To: Cambridgeshire County Council General Purposes Committee
Authors: Richard Cushing and Edward Leigh, Smarter Cambridge Transport
Subject: Review of Capita report and recommendations on guided busway defects
Contact: 01223 312 377 / edward@smartertransport.uk / [@SmarterCam](https://www.facebook.com/SmarterCam)

Cambridgeshire Guided Busway Defects

Figure 1: Cross-section of the busway showing a typical 15m 'ladder section' and one of three shallow foundations.

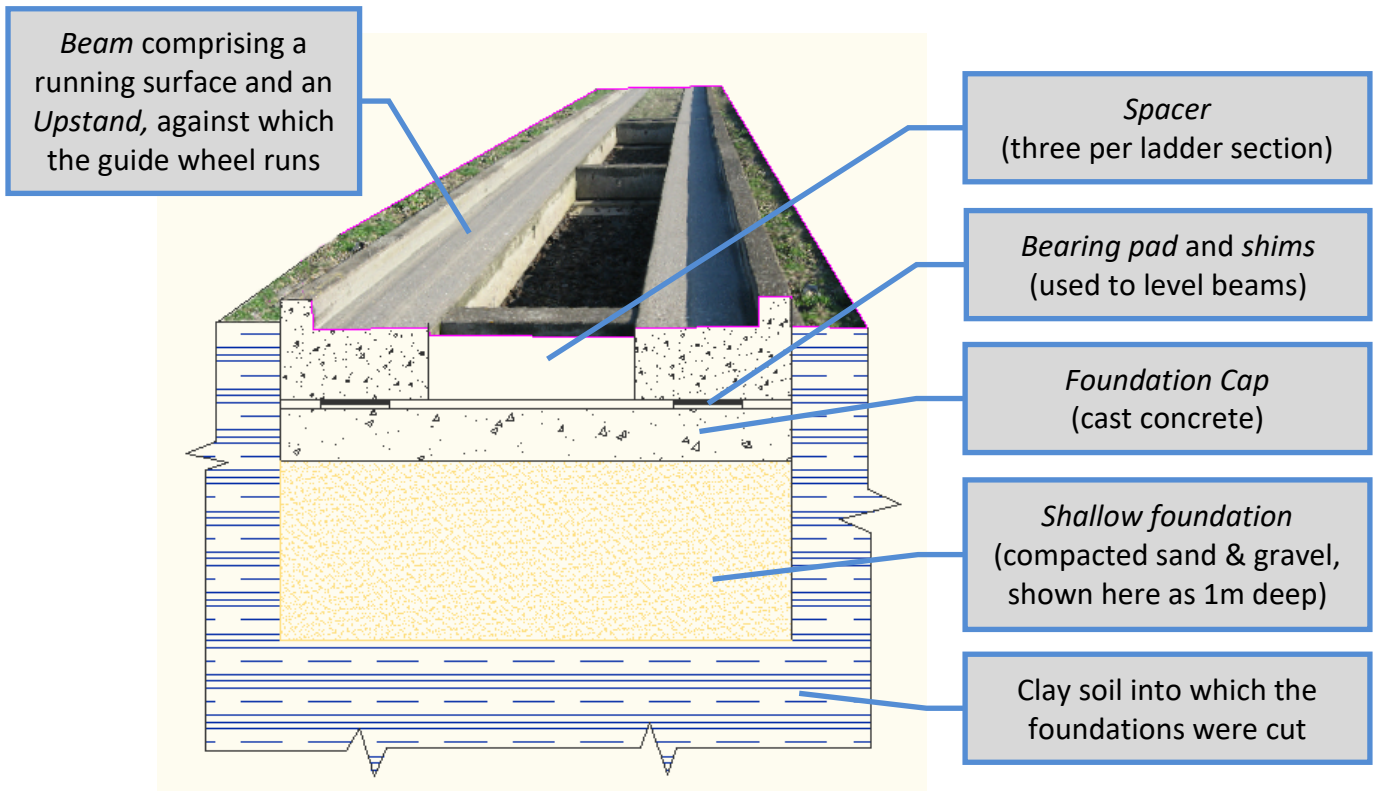
What analysis has been carried out to quantify the risk of derailment (e.g. owing to a beam up-stand breaking away under load, or a guide wheel riding up a damaged beam end)? Has the effect of derailment been modelled for a double-decker bus, in particular on a section where the centre of the guideway is open or in-filled with loose rubber, as shown in Fig 1 below?

Figure 2: Shallow foundation [2-Fig 7]. 821 of these are to be re-excavated, deepened and re-instated

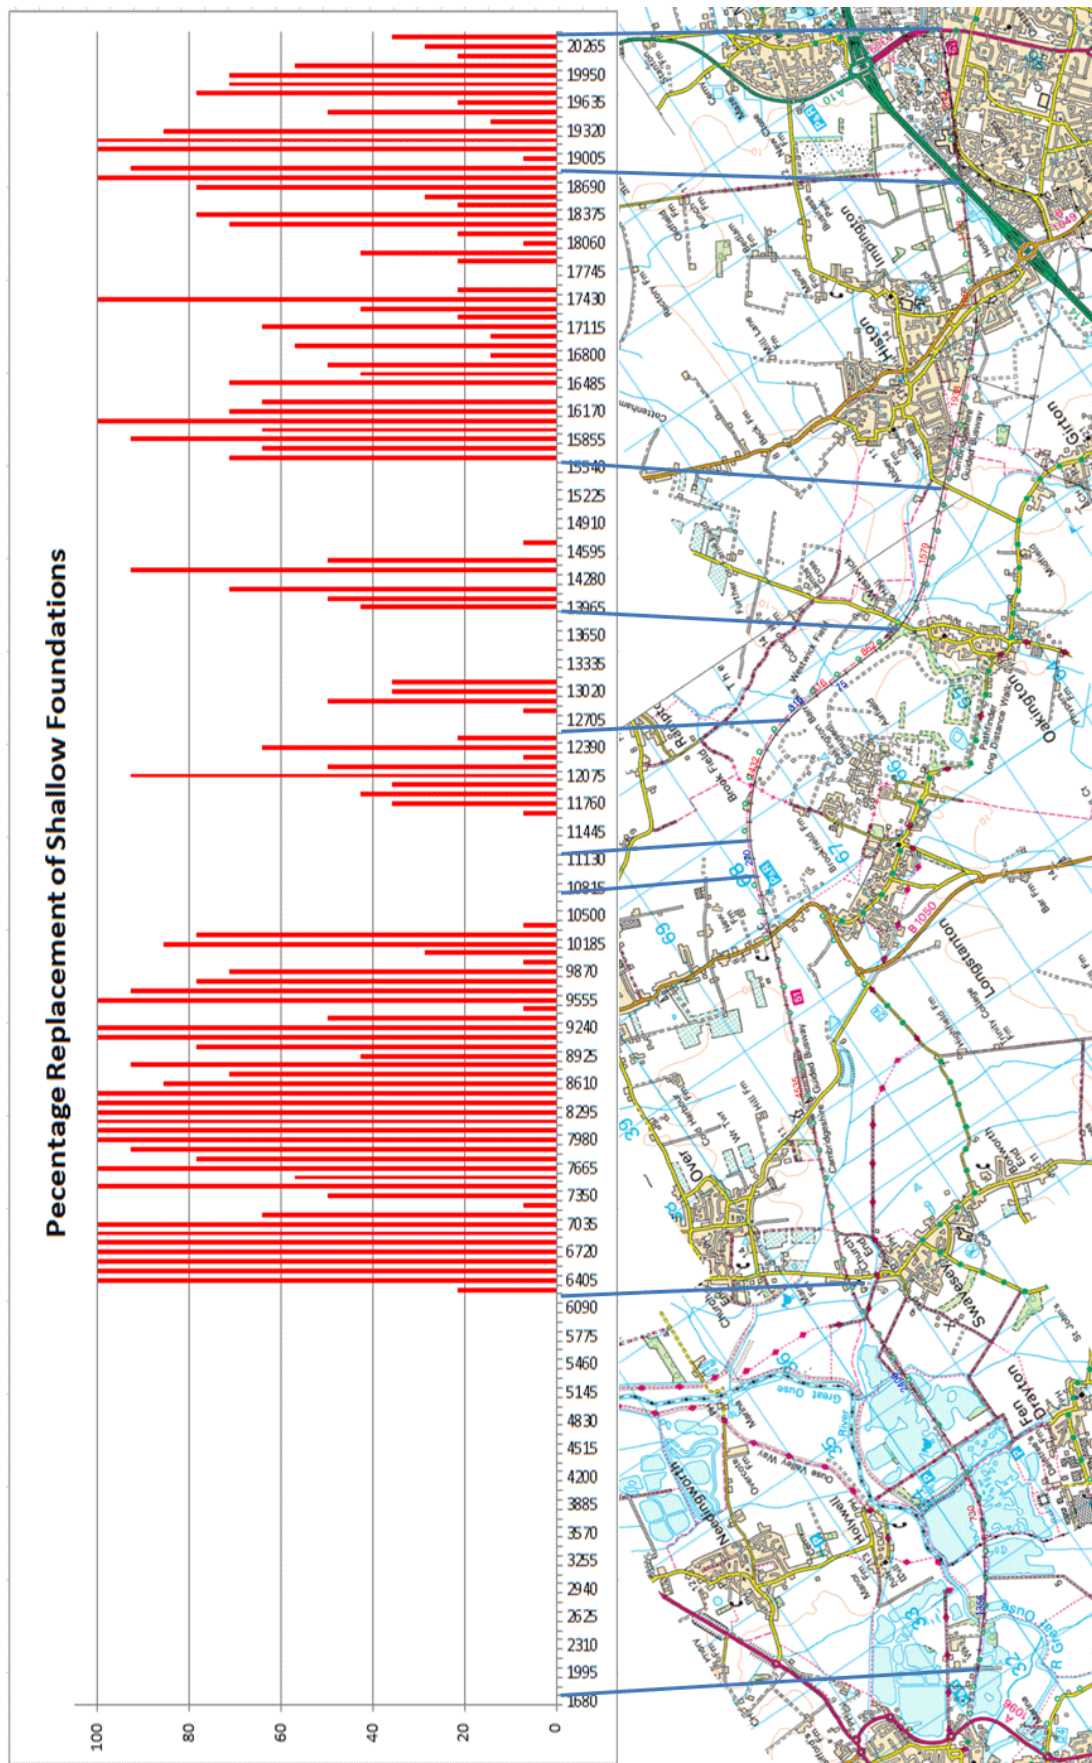
The size of the 'shallow' foundations are noted in the 2014 report [1 – p7, Fig 7], reproduced above (Fig 2). It would appear from the photograph that the volume of material present in such a foundation would require several journeys by heavy vehicles to remove it. The report notes that 821 of these foundations are to be excavated, deepened and re-established, using compacted Class 6N fill. It is unclear whether all of the excavated material will be removed from site and fresh material brought to the site, or whether some of the original material may be re-usable.

How many heavy vehicle movements will be required to dispose of material excavated from the foundations, and how many more will be required to bring fresh material onto the site? Has any consideration been given to the overall environmental impact of carrying out the remedial work proposed in the 2016 report [2]? If so, could a copy of the assessment be provided?

Figure 4: Centre of guide rail, showing V-notch and cracking. Scale bar: 1m.

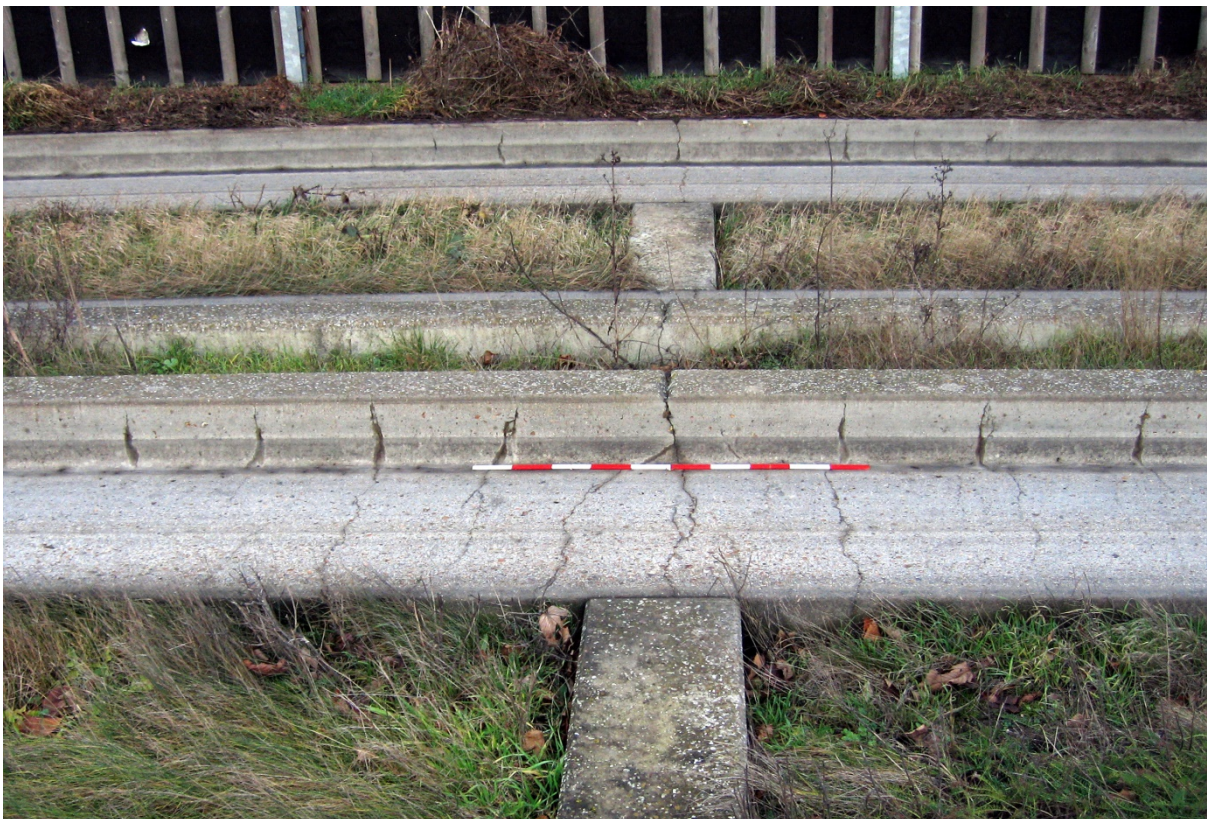
Figure 4 shows part of the St Ives-bound guideway in the foreground, with the Cambridge-bound guideway behind. The length of beam in the foreground is approximately three metres. This pattern of cracking is typical of many in the Histon area.

Question 2.1.1

Is it the case that the cracking shown in the beams in Figure 4 is caused by heave in the centre of the beam or is there some other explanation?

Figure 6b: Rear wheels create an offset load on the bearing stack, causing the beams to roll. This puts stress on the beams, spacers and fixings, and tends to force the stack outwards as shown below.

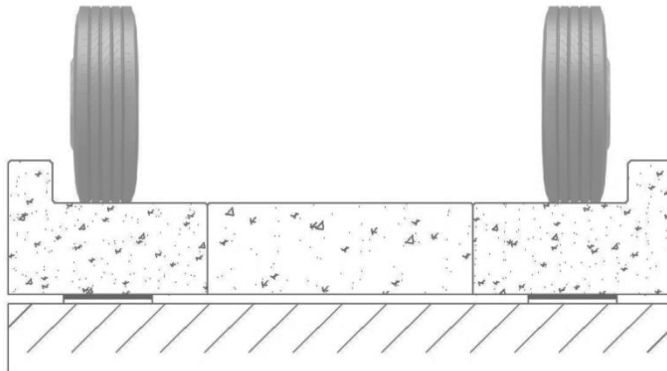
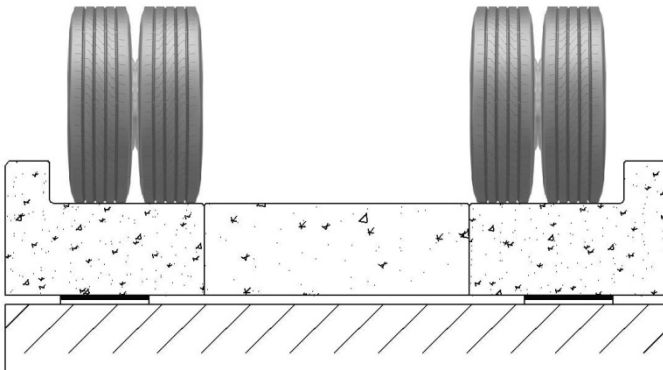
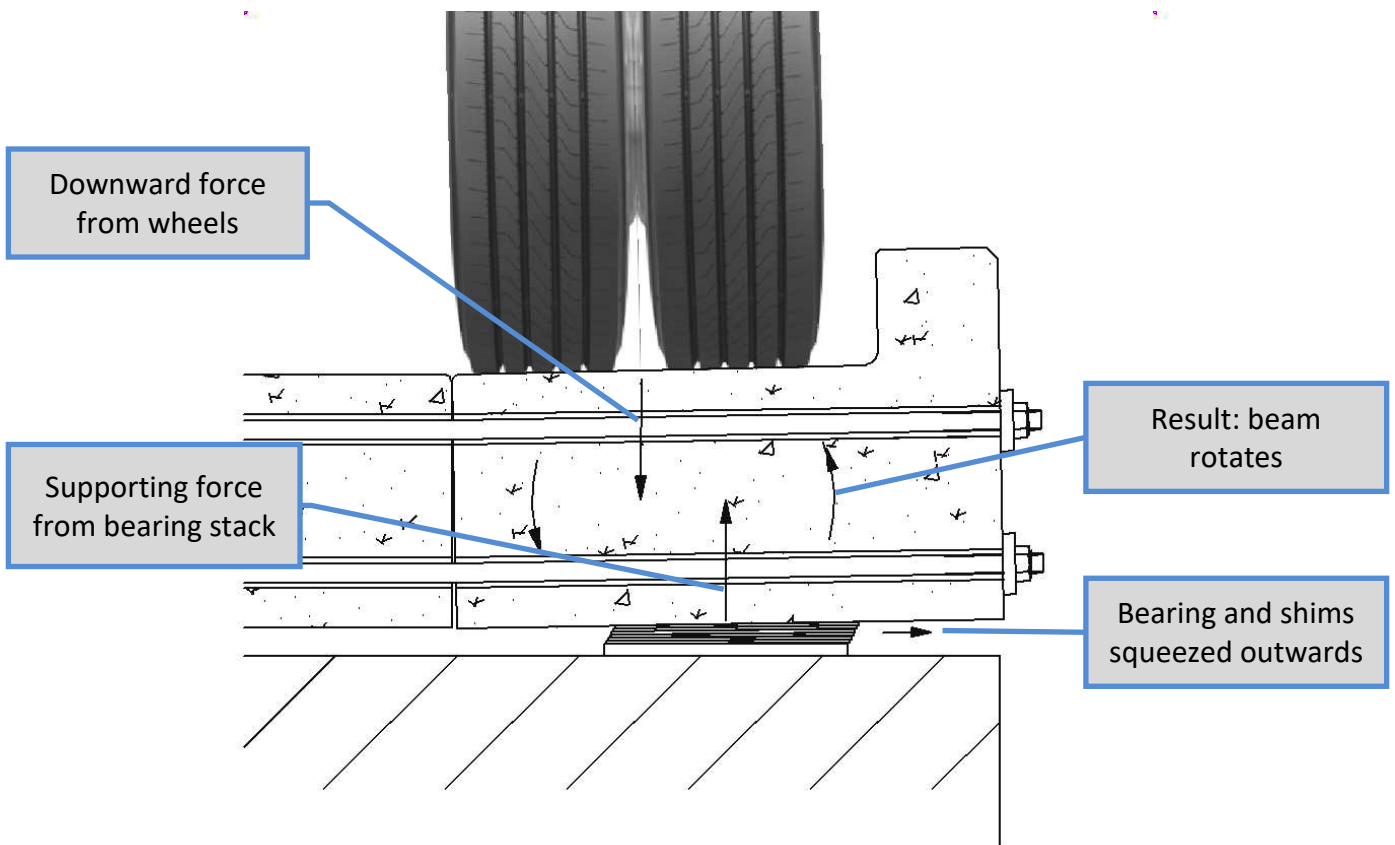
Figure 6 indicates the loading from front (single) (Fig 6a) and rear (double) wheels (Fig 6b). It will be seen that the bearings directly support the load on the front wheels.

However the rear wheels put a load inside the bearing and shim stack. The inner edges of the beams roll away from the spacers; the through bolts stretch and allow the beams to push the beams outward. Friction between the foundation block, bearing, shims and beam is not sufficient to constrain the movement.

Question 4.1

It appears that vehicles with twin wheels (typical on the rear axle) are likely to cause the beams to roll inward as the vehicle passes along the guideway. In the suggested

repairs to the Busway, has any account been taken of the possibility that the bearing area is not large enough to support the beams, and of the potential degradation which this may continue to cause?

Figure 8: Indicative profile of the ride for extended sections of the Busway. The observed motion of the vehicle will differ from

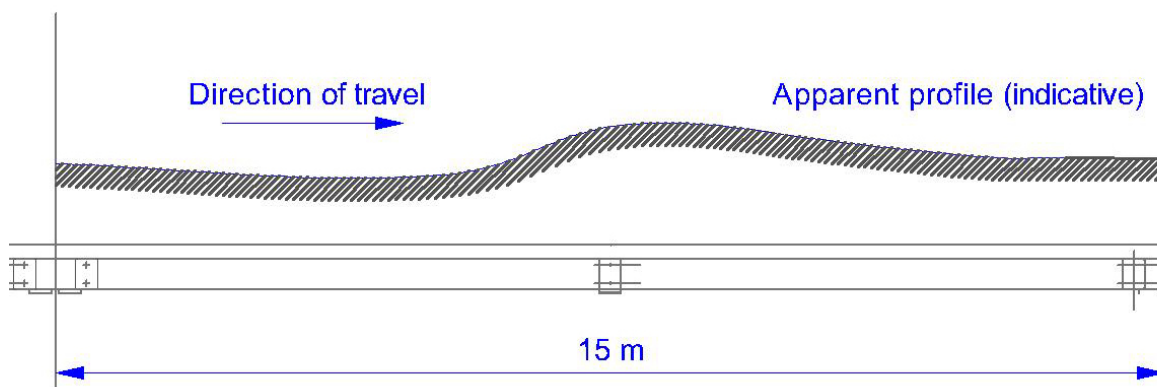
Question 4.2.1

Has any consideration been given to the cause of the poor ride quality along significant sections of the Busway, and in particular whether variation in height of the foundations may be due to percussive loading at the joints of the beams?

Figure 9: Action and reaction of a beam as it is receives an impact from a loaded wheel.

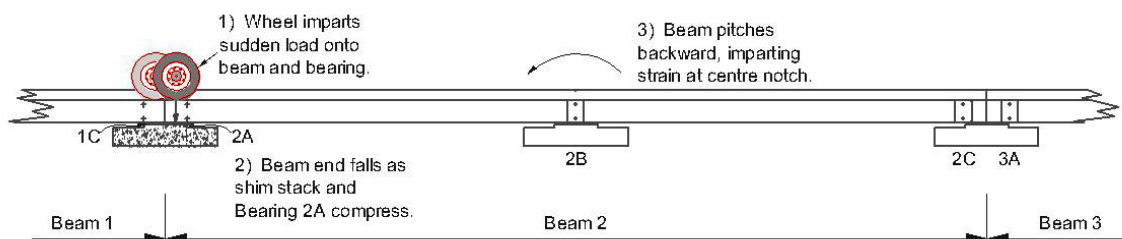
With an 18 tonne dual axle bus approximately 3.5t is taken on each of the front wheels. With the wheel at the end of Beam 1, the load on 1C is a total of 7.3t (beam with bus), and the load on 2A is 3.8t (beam alone).

When the wheel crosses onto Beam 2, the situation is reversed, and load on the bearing 2A suddenly increases from 3.8t to 7.3t. The shims and bearing will be flattened and compressed; the beam end receives a sharp blow (mitigated by the vehicle tyres) and will move downwards.

Bearing 2B is already loaded by half of the weight of the beam. It takes little of the additional weight of the bus, so initially the effect will be that the distant end of the beam rises, offloading 2C. The rotational torque is imparted by tension in the beam above the centre, concentrated around the V-notch.

We suggest that a significant reason for cracking is cyclical percussive loading as bus wheels hit the start of each beam.

We suggest that a significant reason for differential settlement of the foundations is because of percussive loading by wheels as they impact the start of the beam. The loading on the centre foundation is much smoother by comparison.
